SUNDRY NOTICES AND REPORTS ON WELLS

8. Well Name and No.
LUSK WEST DELAWARE #914
UNIT

PROPOSED PLUGGING AND ABANDONMENT PROCEDURE:

RE: Plugging and Abandonment Requirements, Conditions of Approval

COMPLETION SCHEMATIC

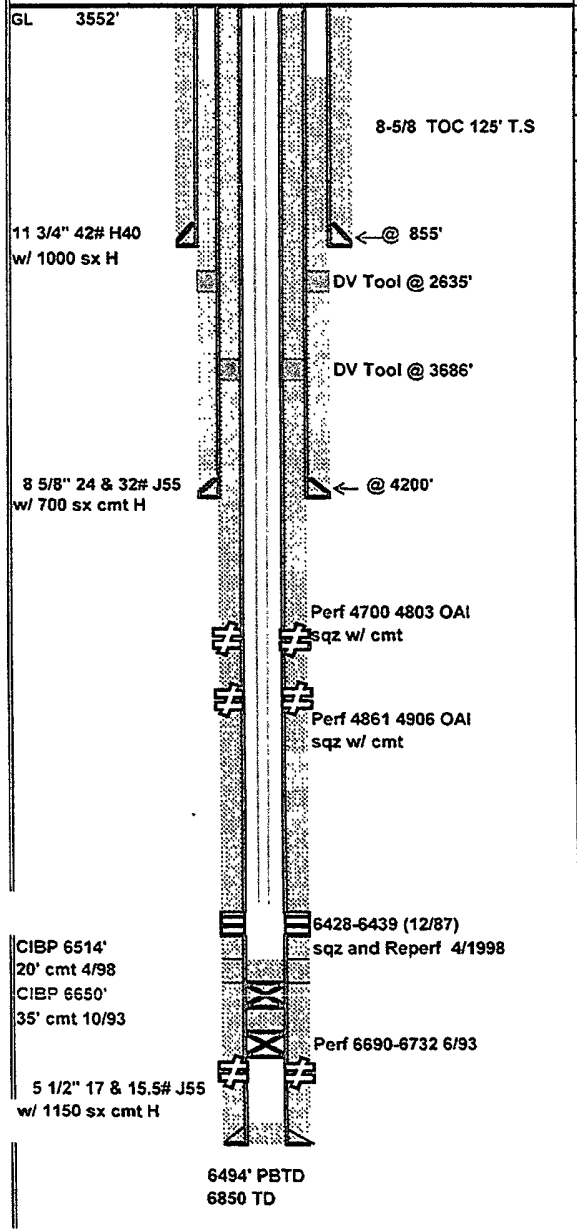
0. Additional cement is required on CIBP at 6514'. An additional 15' bailed or 25sx pumped Class C cement.
1. OK (Perfs)
1a. Spot a cement plug from 4960'-4650'. WOC and tag at 4650' or shallower (Perfs)
2. WOC and tag at 4100' or shallower – Otherwise OK (Casing shoe)
3. WOC and tag at 3586' or shallower – Otherwise OK (DV Tool)
4. WOC and tag at 2492' or shallower – Otherwise OK (DV Tool – Delaware – BOS)
5. WOC and tag at 800' or shallower – Otherwise OK (TOS – Casing shoe)
6. OK (Surface)
7. Verify that all annuluses have cement to surface and fill in as required – Otherwise OK.
8. Submit a subsequent report to the BLM.
